OIL INDIA LIMITED
(A Government of India Enterprise)
P.O. Duliajan – 786602, Assam, India
Website: www.oil-india.com

Corrigendum No. 5 to IFB No. CPG2023P20

**Engineering, Fabrication and Construction, Testing and Commissioning
of Modular Field Gas Gathering Station at Baghjan, Assam**

OIL's/ EPMC's response to Bidder's queries to various sections of Tender documents.

SINGLE LINE DIAGRAM

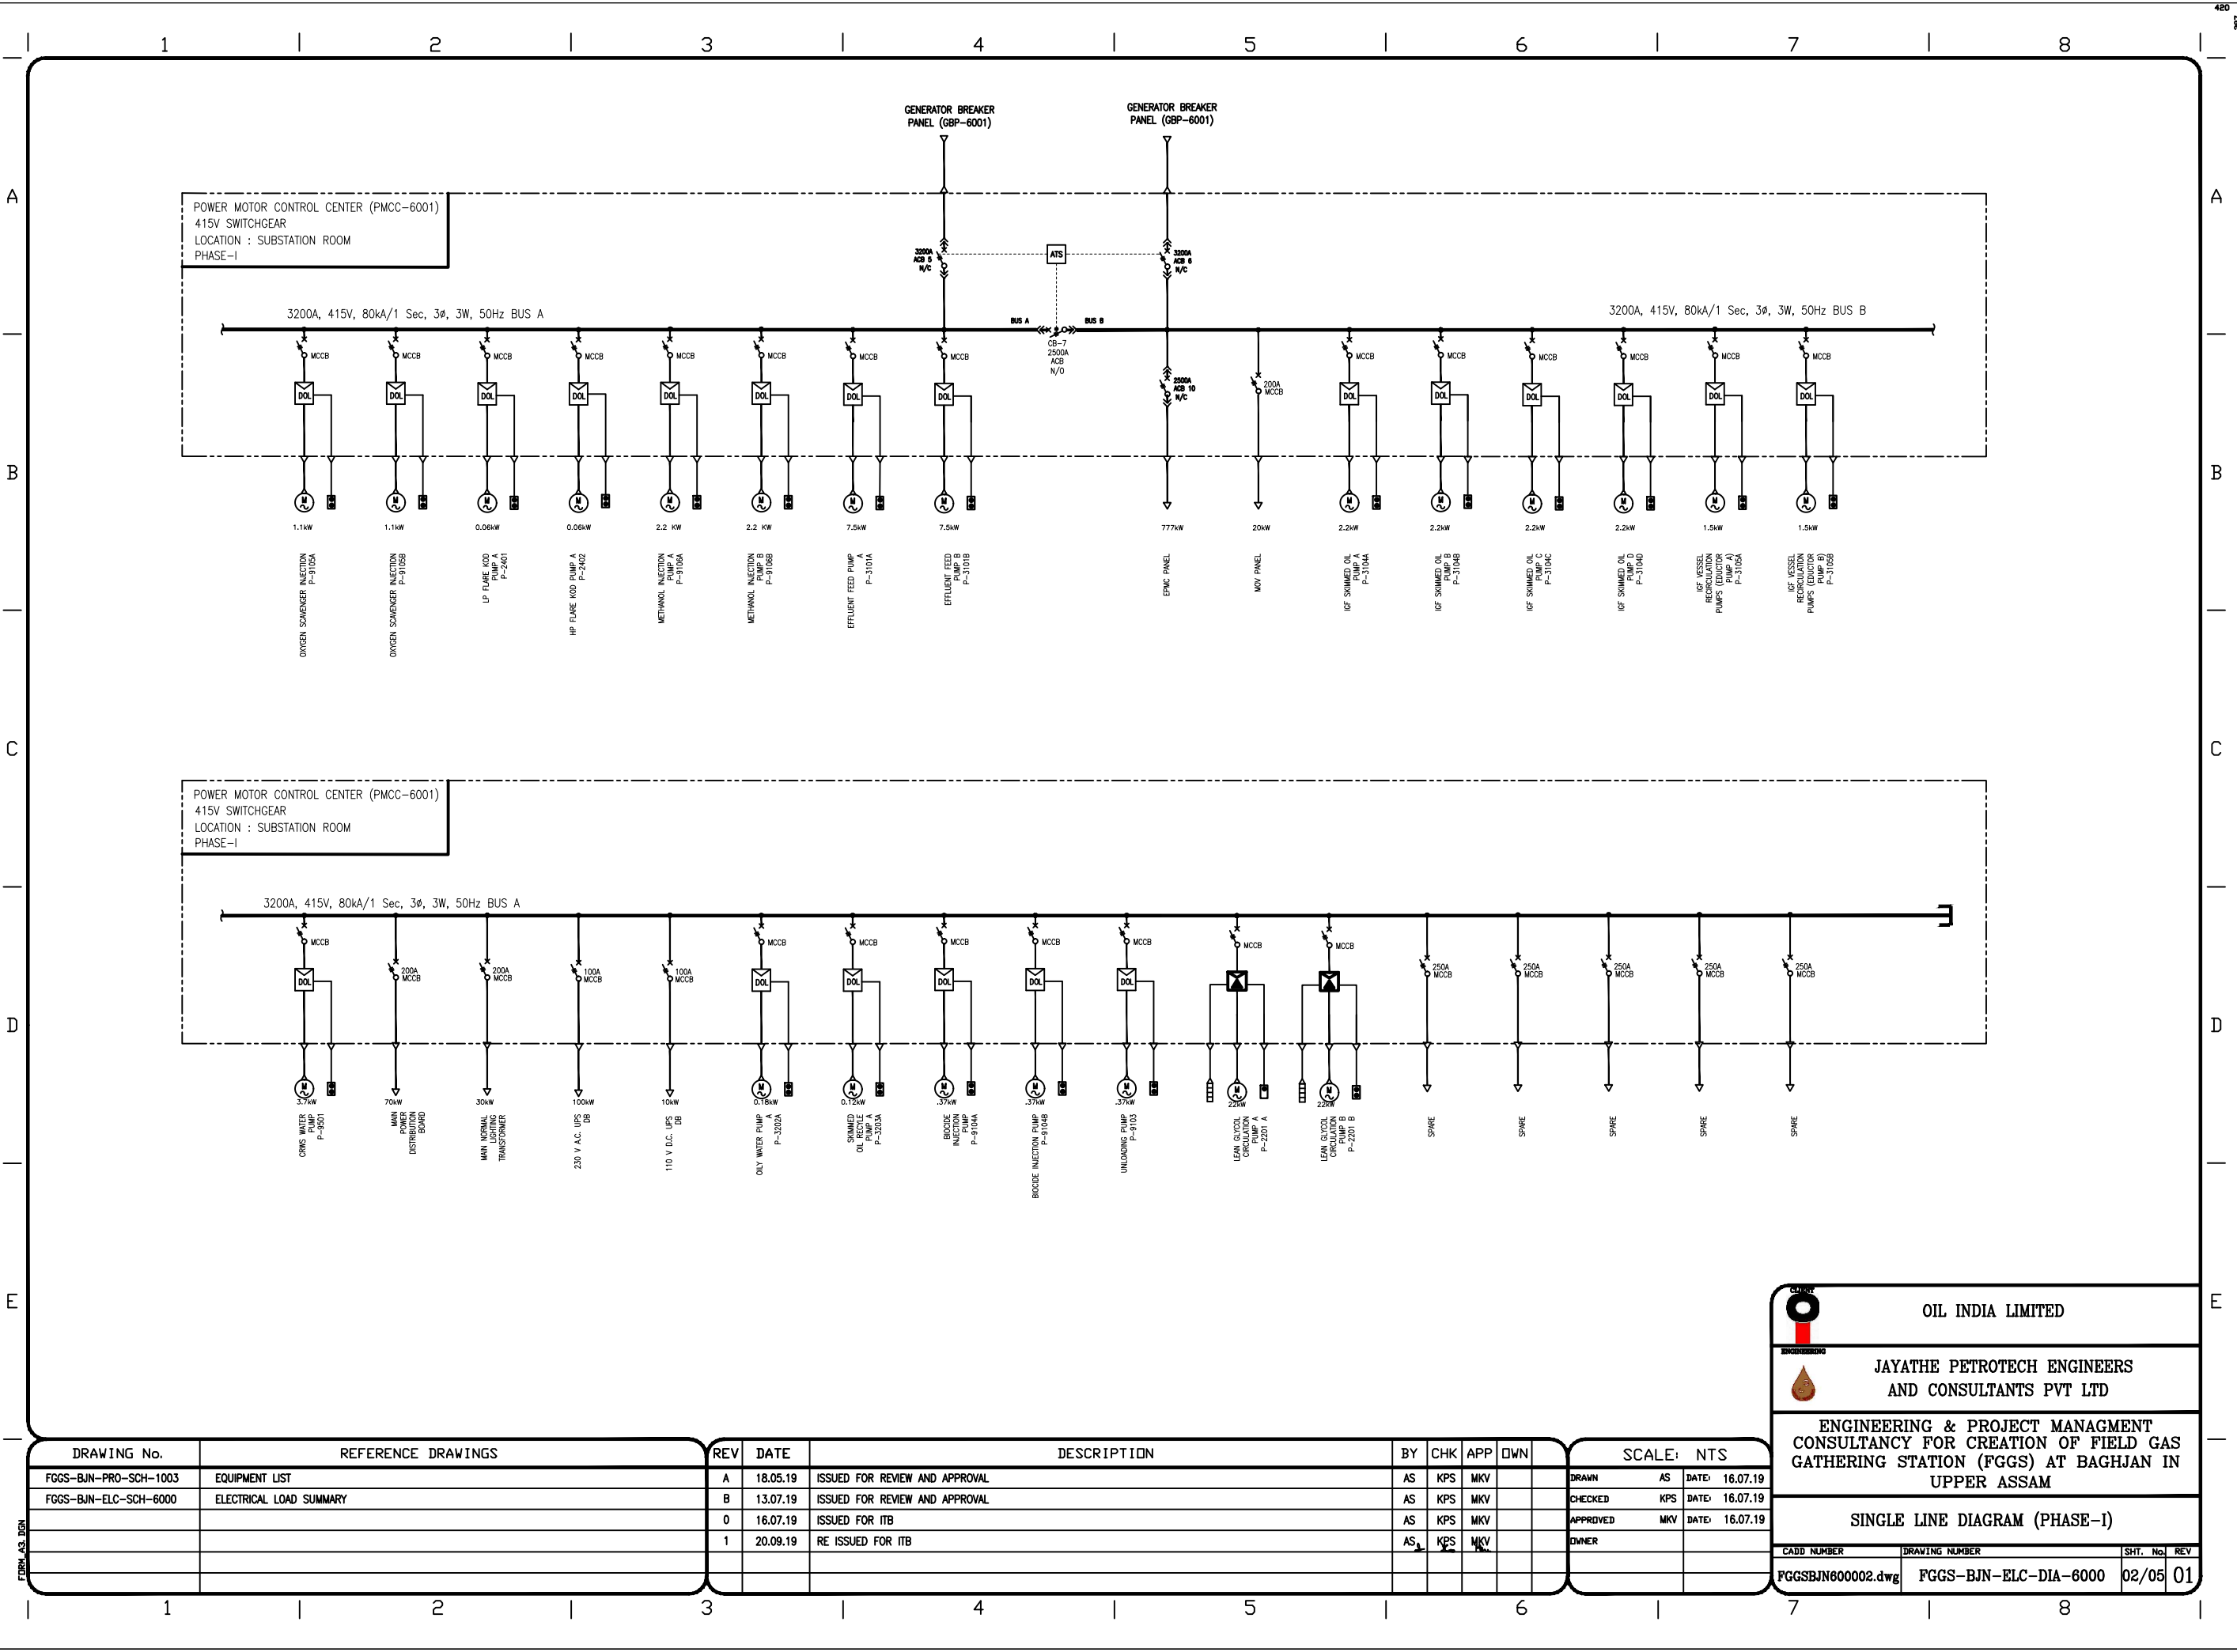
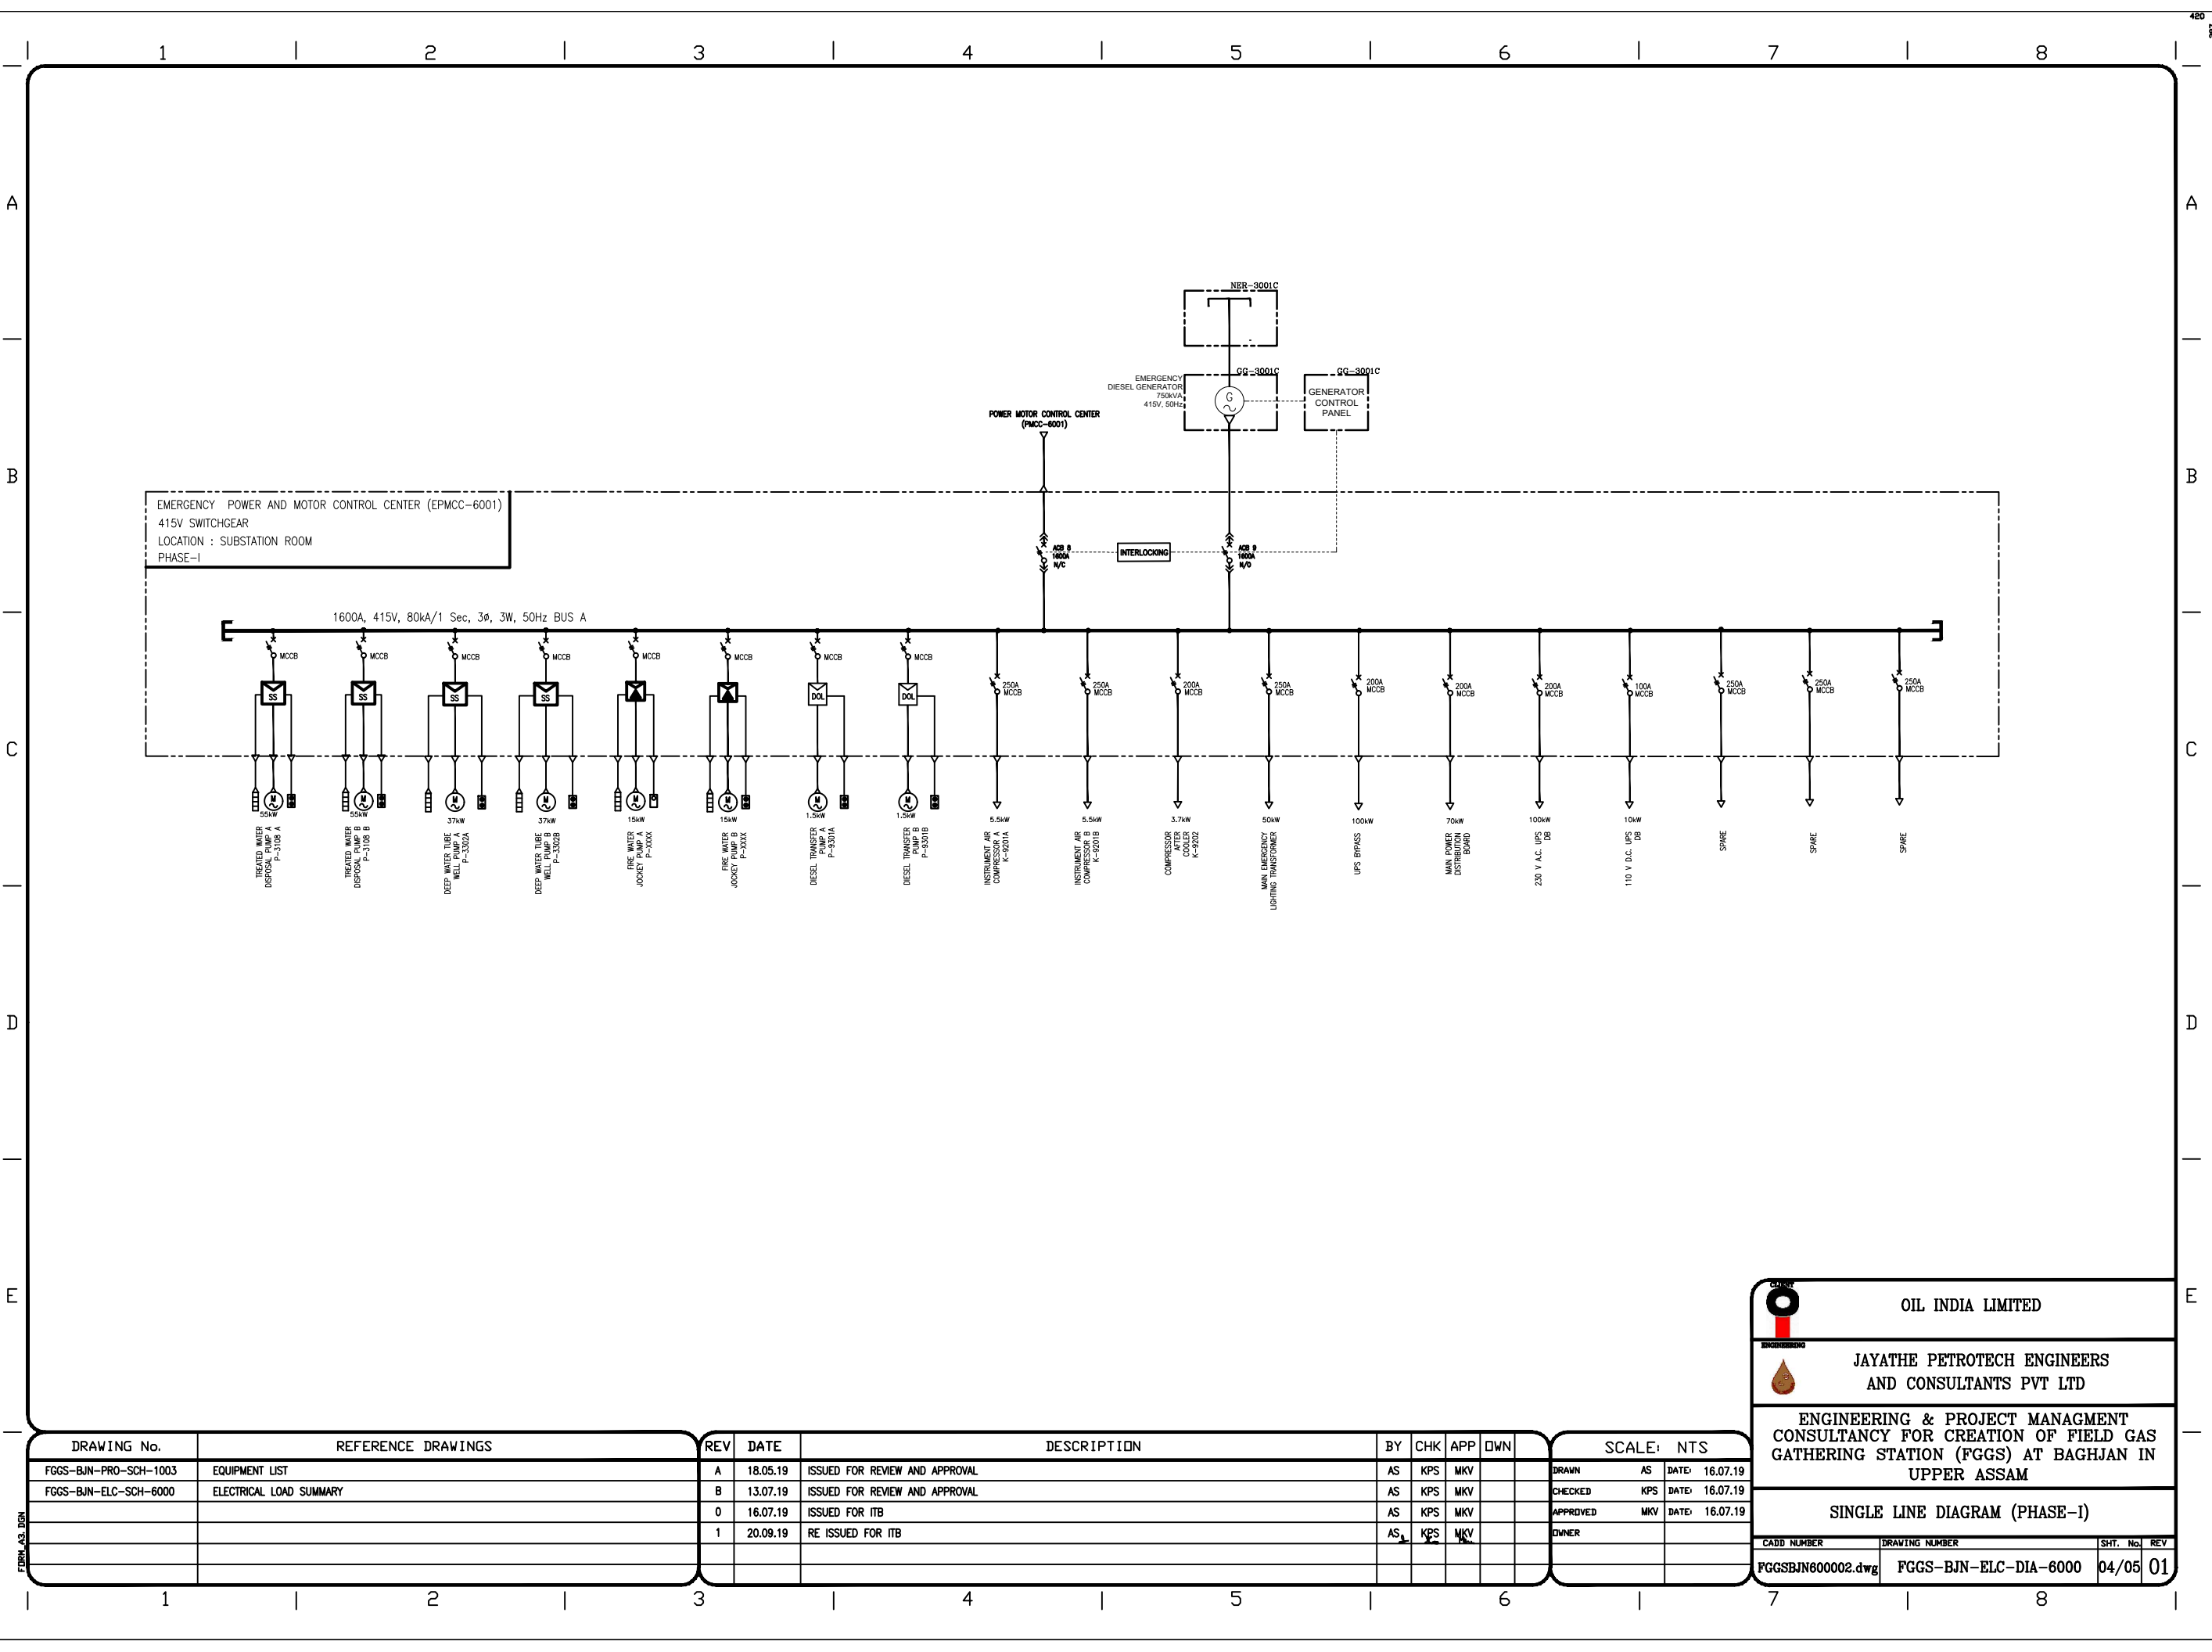
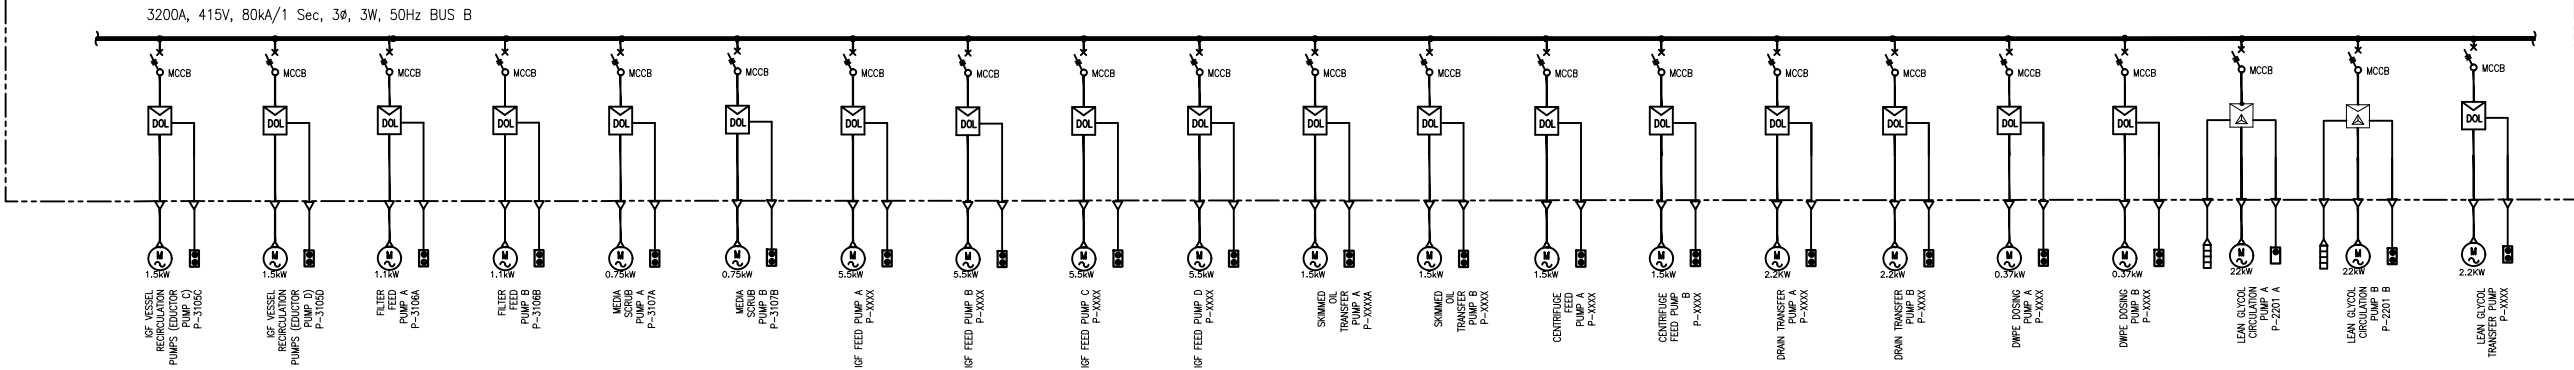
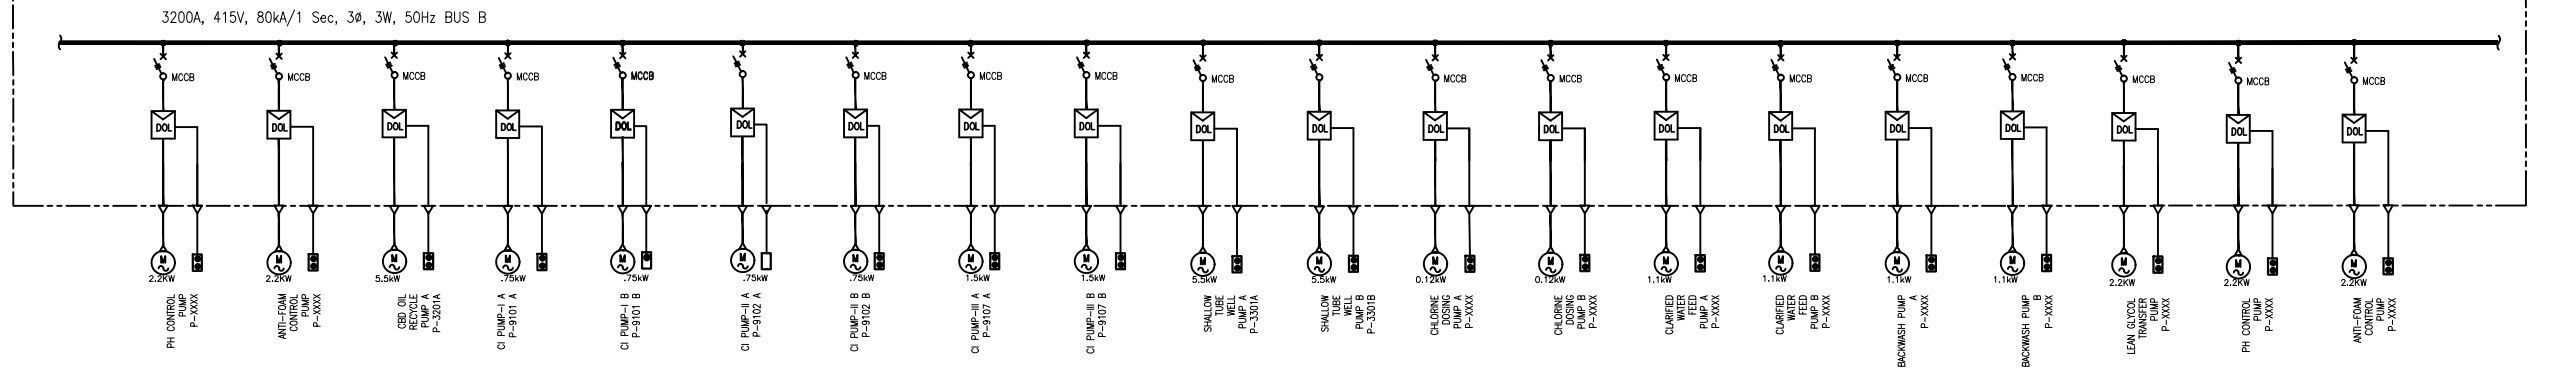
10	CORRIGENDUM No. 01, IFB No. CPG2023 P20 / ELECTRICAL DESIGN BASIS, Page No. 31 of 44 (1289 of 2248)	BUS DUCT	BUS DUCT “ <u>Consultant/ OIL's Response:</u> There is no separate datasheet/ specification has been prepared and for basic details refer clause 11.10 in electrical design basis. This shall be as per international codes and standards.	As per Client's clarification (S. No. 101), Bus Duct type mentioned in Electrical design Basis (FGGS-BJN-ELC-DBM-6000) (Clause No. 11.10) is “ Non-phase segregated , self-cooled type, sandwiched type” but Bus Duct type mentioned in SLD (FGGS-BJN-ELC-DIA-6000 -02/06) is “ Sandwich type ”. Kindly clarify which type required.	Please refer Annexure-B of Attachment-II of this Corrigendum.
11	Technical Tender_Final-9, Page No.1550/ 2248	SLD Bus Coupler Rating		Kindly note that, in worst condition also bus coupler will only see only Gas Generator Full Load Current (i.e. Approx. 2500A). Hence, bidder recommends considering Bus Coupler current rating as 3200A matching with incomer breaker. Request to kindly confirm our understanding.	Bus coupler current rating shall be equal to the incomer. Bidder shall follow the updated SLD attached as Annexure-B of Attachment-II of this Corrigendum.

12	Technical Tender_Final-9, Page No.1555/ 2248	SLD Bus Coupler Rating		Kindly note that, in worst condition also bus coupler will only see only 800A current (Incomer breaker rating). Hence, bidder recommend considering Bus Coupler current rating as 630A (80% of Incomer breaker rating) as standard practice. Request to kindly confirm our understanding.	Bus coupler current rating shall be equal to the incomer. Bidder shall follow the updated SLD attached as Annexure-B of Attachment-II of this Corrigendum.

64	Vol-II, Technical	Single Line Diagram Page no.1550 of 2248	SLD	Modification	Please refer Attachment-II of Corrigendum No. 5.	
65	General				The above-mentioned changes shall be applicable to all specification and datasheet which is part of the tender. The above changes supersede the tender documents.	
66	General		List of approved manufacturers of the critical electrical components/ items.	Addition	Please refer Attachment-I of Corrigendum No. 5.	
67		1512 of 2248	Data sheet Sl. No. 17	Modification	1875 kVA at 0.8 pf	Minimum 1875 kVA at 0.8 pf with higher rating up to 10% acceptable.
68		1518 of 2248	Data sheet Sl. No. 5.0	Modification	750KVA at 0.8 pf	Minimum 750KVA at 0.8 pf with higher rating up to 10% acceptable.
69	Volume-I, Commercial	BEC/BRC		Modification		Modified BEC/BRC is attached as Attachment-III
70	Volume-I, Commercial	SOR/P		Modification		Modified SOR/P is attached as Attachment-IV
